# Executive Director's Recommendation

Commission Meeting: March 7, 2019

<b>PROJECT</b> <b>WMATA Escalator Canopy Program - Phase 4</b> Various Locations Washington, DC	<b>NCPC FILE NUMBER</b> 8043
	<b>NCPC MAP FILE NUMBER</b> 00:00(40.00)44875
<b>SUBMITTED BY</b> Washington Metropolitan Area Transit Authority	<b>APPLICANT'S REQUEST</b> Approval of comments on concept design
<b>REVIEW AUTHORITY</b> D.C. Code § 9-1107.01, Washington Metropolitan Area Transit Authority Compact	<b>PROPOSED ACTION</b> Approval of comments on concept design
	<b>ACTION ITEM TYPE</b> Staff Presentation

# WMATA Escalator Canopy Program - Phase 4

## Option 2

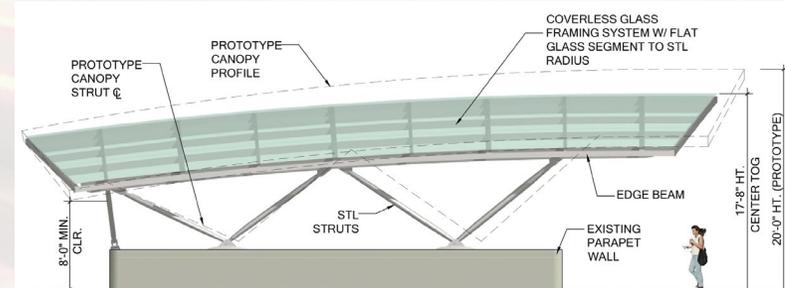
**Recommends** the applicant explore ways to design Option 2 to provide more overhang on the sides, in keeping with the original canopy design.

Staff also notes that Option 2 varies somewhat in the amount of overhang and weather protection provided at the canopy sides. The overhang is important to preventing rain and snow from impacting well-ways. Therefore, staff suggest the **Commission recommend the applicant explore ways to design Option 2 to provide more overhang on the sides, in keeping with the original canopy design.**

## Option 3

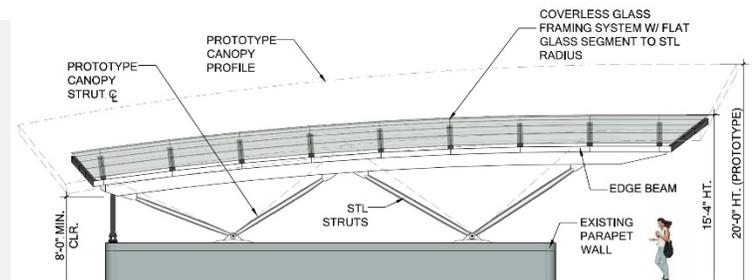
**Finds** Option 3 is inappropriate for use at any of the locations as its flattened appearance is too great a departure from the original canopy prototype design and the arched form that is most reminiscent of the Metrorail system.

# Archives-Navy Memorial-Penn Quarter

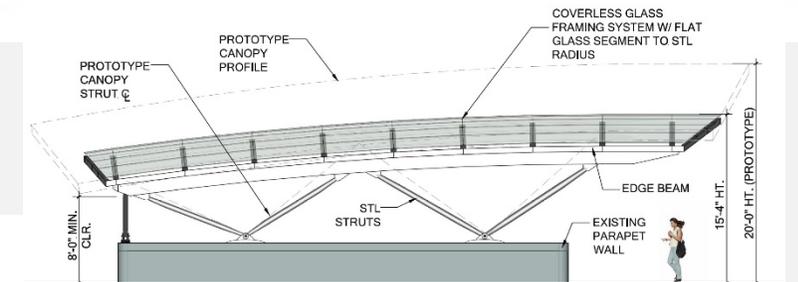
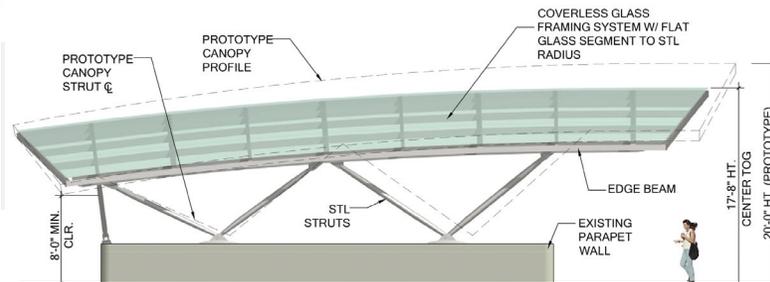
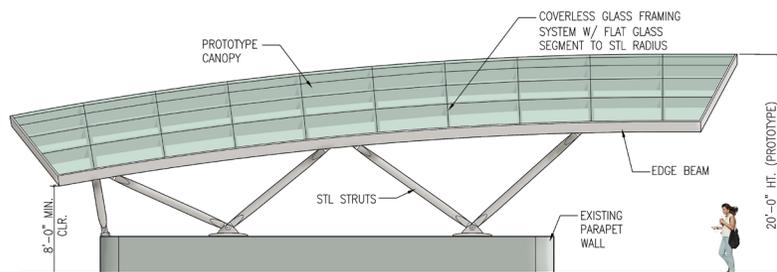
**Finds** Option 1 is appropriate for the Archives-Navy Memorial Penn Quarter Station, as the canopy is in an urban area, would not impact any historic buildings, nor would it significantly impact any important viewsheds.

The station entrance is located to the east of the Navy Memorial. It is set in a lawn area with trees and is located northwest of the Major General Winfield Scott Hancock Statue. The site is highly urbanized and heavily used. Adjacent mixed-use buildings are not historic and over ten stories tall. The station is located outside important viewsheds, such as the Pennsylvania Avenue corridor, or 10<sup>th</sup> Street, NW between the National Archives and the National Portrait Gallery. Therefore, staff recommends the **Commission find Option 1 is appropriate for the Archives-Navy Memorial Penn Quarter Station, as the canopy is in an urban area, would not impact any historic buildings, nor would it significantly impact any important viewsheds.**

*Archives / Navy Memorial / Penn Quarter station.* For this entrance adjacent to the Navy Memorial plaza, the Commission members approved alternative #1, commenting that its greater height is appropriate within the broad spatial context of Pennsylvania Avenue and would allow for continuity of horizontal views.

# Arlington Cemetery (North and South)

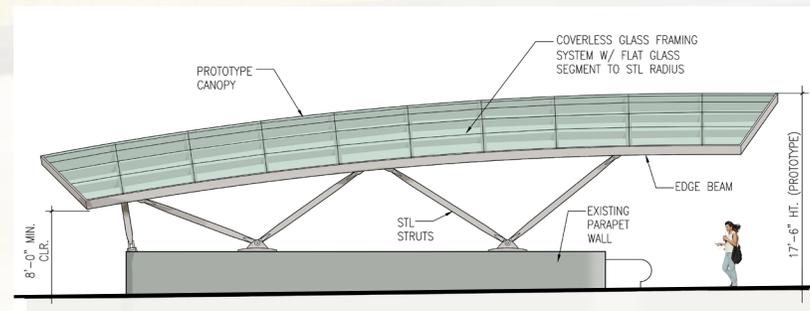
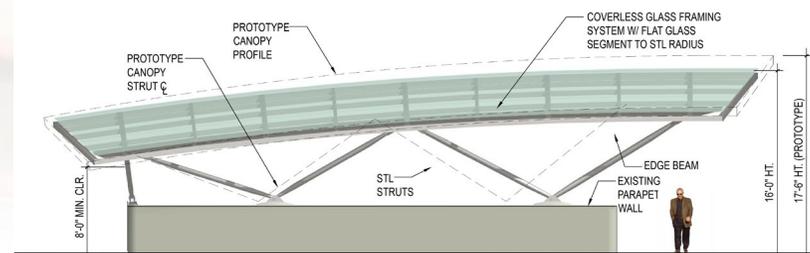
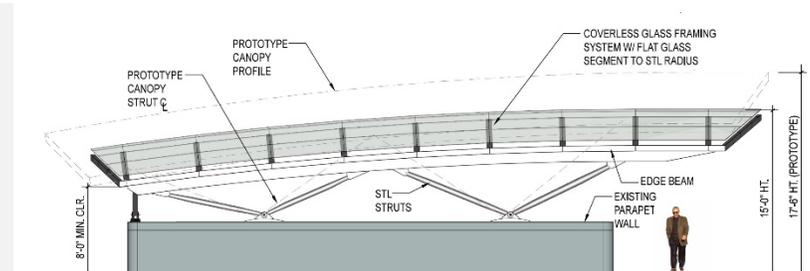
**Finds** Option 2 is appropriate at the Arlington Cemetery station as it would help mitigate the visual impacts on important views along Memorial Avenue, including those to the Lincoln Memorial and Arlington House, while providing enough height to provide necessary wayfinding to the Metrorail station entrances.

The lack of canopies currently makes the Arlington Cemetery Station challenging to find for visitors. As such, the canopies will improve wayfinding for this location. However, the setting within the Memorial Avenue corridor also requires additional consideration. Given the important viewshed of this corridor, and historic setting, Option 2 appears most appropriate. The slightly lower profile of the canopy can minimize impacts to views, while still providing wayfinding to the Metrorail entrances. Therefore, staff recommends the **Commission find canopy Option 2 is appropriate at the Arlington Cemetery station as it would help mitigate the visual impacts on important views along Memorial Avenue, including those to the Lincoln Memorial and Arlington House, while providing enough height to provide necessary wayfinding to the Metrorail station entrances.**

*Arlington Cemetery station (both entrances).* For this pair of entrances flanking Memorial Avenue on the ceremonial axis between the Lincoln Memorial and Arlington National Cemetery, the Commission members approved alternative #2. They commented that the expansive context does not require the lowest alternative, while the tallest alternative may be too disruptive to the views along this important corridor. They also observed that alternative #2 relates best to the general horizontal character of the setting and to the height of the adjacent hedges.

# Judiciary Square North

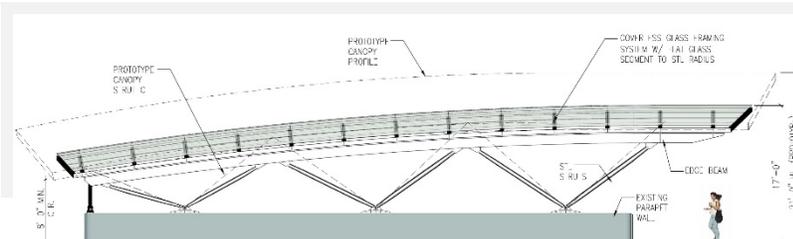
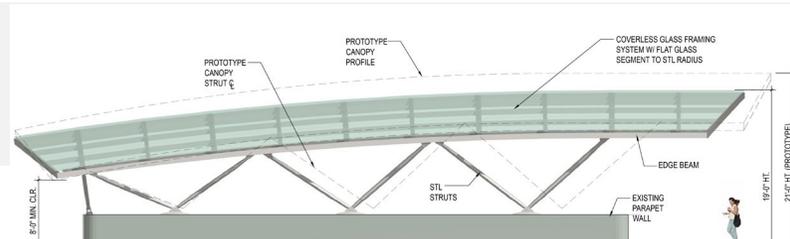
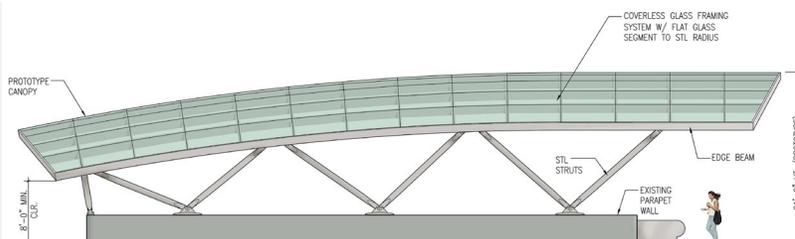
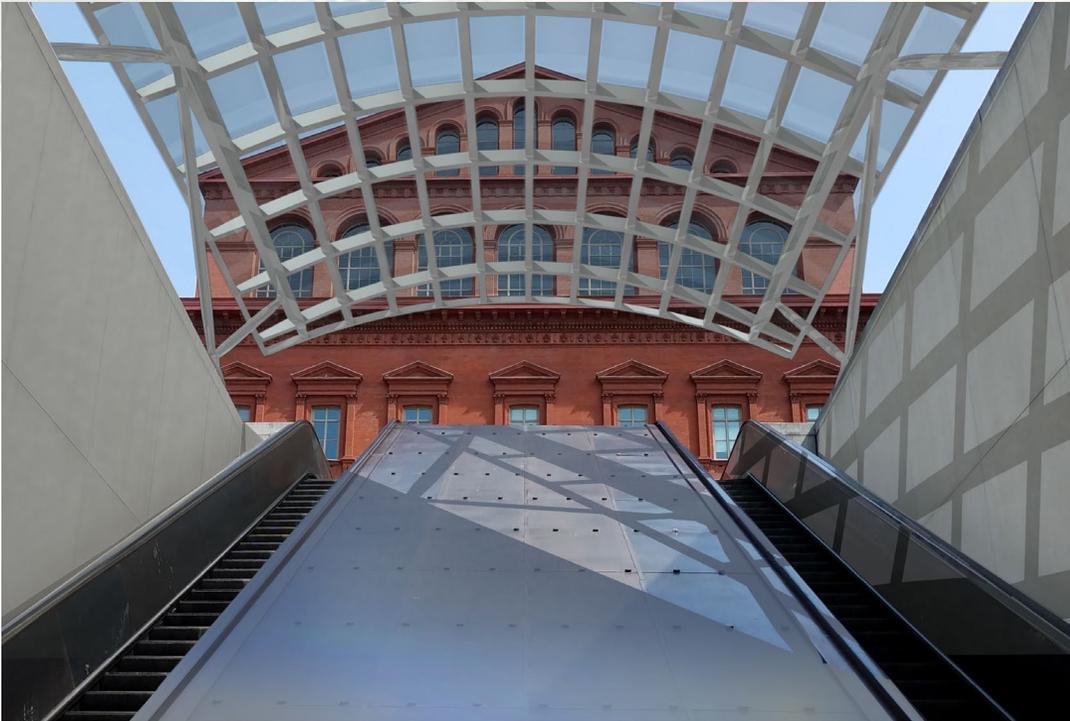
**Finds** Option 2 may be the most appropriate at the Judiciary Square North Station as the lower height and lighter supports could help mitigate the visual impacts on views looking north to the

**Requests** WMATA conduct additional coordination with the National Law Enforcement Memorial to understand any other impacts from the proposed canopy design on the memorial, and to consider any potential modifications that may be appropriate given the setting.

Staff notes that the National Law Enforcement Officers Memorial has expressed concerns about the potential canopy options, and believes additional coordination is necessary with WMATA to ensure a design that is appropriate for the memorial setting. Given this, staff recommends the **Commission requests WMATA conduct additional coordination with the National Law Enforcement Memorial to understand any other impacts from the proposed canopy design on the memorial, and to consider any potential modifications that may be appropriate given the setting.**

*Judiciary Square station (north entrance).* For this entrance adjacent to the National Law Enforcement Officers Memorial, the Commission members did not take an action and requested further documentation of the canopy alternatives in the context of the memorial, as well as consultation with the memorial's architect

and sponsoring organization concerning potential alterations to the memorial in the near future. They noted that the two curving trellises within the memorial's plaza have a form that is similar to the proposed canopy design; they requested further consideration of this relationship and additional perspective views of the canopy alternatives that include these existing trellises. They asked that current planning for increasing the height of the memorial's curved walls should also be considered and documented. In order to clarify the impact of the three proposed alternatives, they requested a further concept submission for this location.

# Smithsonian North

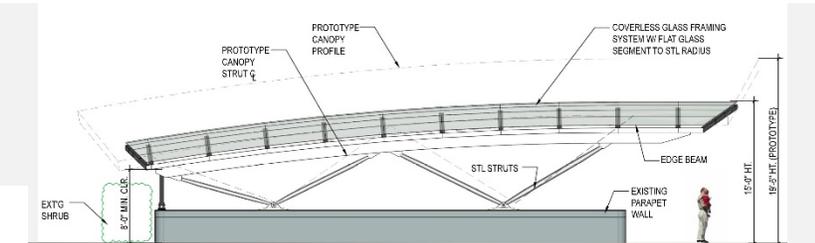
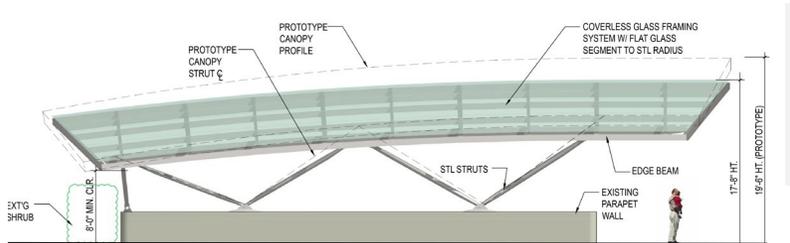
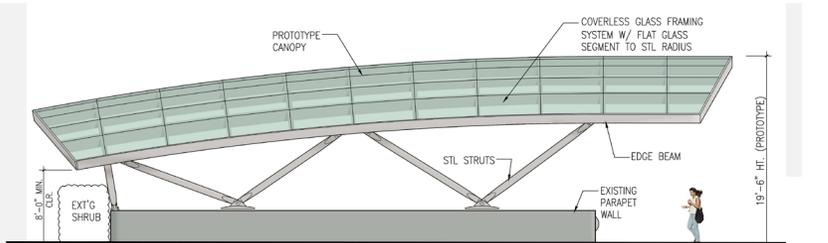
**Finds** Option 2 is appropriate at the Smithsonian Institution North station as it would help mitigate the visual impacts on important views along the Mall, including those of the Smithsonian Castle and the Washington Monument, while providing enough height to provide necessary wayfinding to the Metrorail station entrance.

The Smithsonian Station is located within a panel of the National Mall. It is screened by hedges and surrounded by trees. As such, it can be difficult to find, particularly for visitors. In this location, the canopy could impact views along the National Mall, including the Smithsonian Castle and Washington Monument. Given this, Option 2 appears most appropriate for the location. The slightly lower profile of the canopy compared to Option 1 can help minimize impacts to views, while still providing wayfinding to the station entrances. Therefore, staff recommends the **Commission find Option 2 is appropriate at the Smithsonian Institution North station as it would help mitigate the visual impacts on important views along the Mall, including those of the Smithsonian Castle and the Washington Monument, while providing enough height to provide necessary wayfinding to the Metrorail station entrance.**

*Smithsonian station (north entrance).* For this entrance adjacent to the main axis of the National Mall, the Commission members approved alternative #1, commenting that its greater height is commensurate with the vast scale of the Mall's open space. They likened the canopy's visual presence to other secondary features on the Mall, such as the nearby carousel and service kiosks.

# U Street/African-American Civil War Memorial (East)

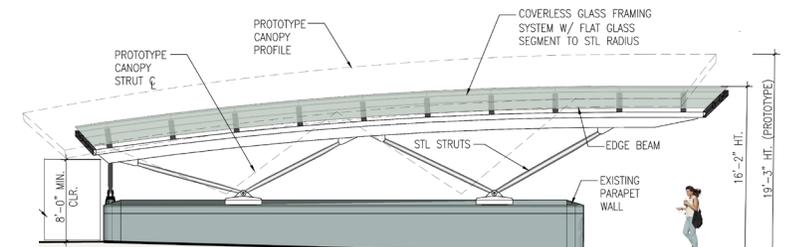
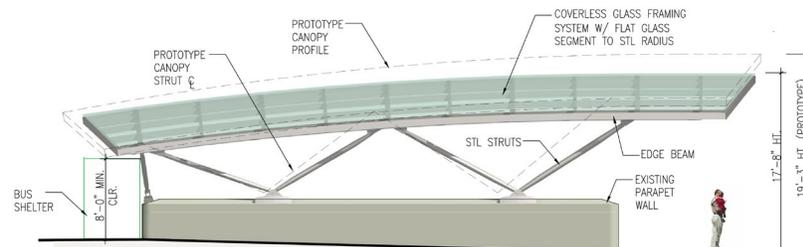
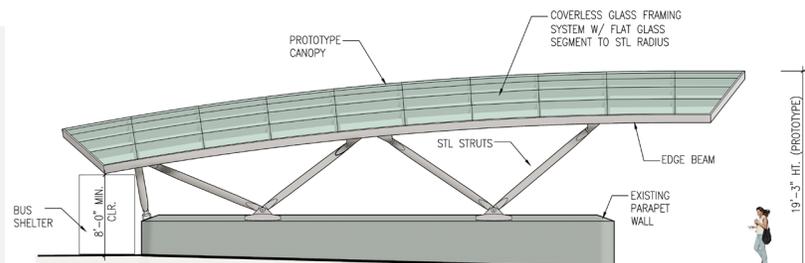
**Finds** Option 1 is appropriate for the U Street/African-American Civil War Memorial Station, as the station entrance is relatively small and set back from the adjacent memorial.

The U Street/African-American Civil War Memorial Station is located near the corner of U Street and Vermont Avenue, NW. The station context includes the memorial, as well as a mix of residential and commercial uses in an urban setting. The station entrance is located in a plaza area, and is relatively small with only two escalators. In addition, it is set back from the memorial some distance, and aligns with the primary sculpture elements. As such, Option 1 (the prototype design) appears appropriate for use at this location. Therefore, staff recommends the **Commission find Option 1 is appropriate for the U Street/African-American Civil War Memorial Station, as the station entrance is relatively small and set back from the adjacent memorial.**

*U Street / African-American Civil War Memorial / Cardozo station (east entrance).* For this entrance adjacent to the African-American Civil War Memorial, the Commission members approved both alternatives #1 and #2, commenting that these configurations would be high enough to allow for continuity of horizontal views across the surrounding plaza toward the memorial.
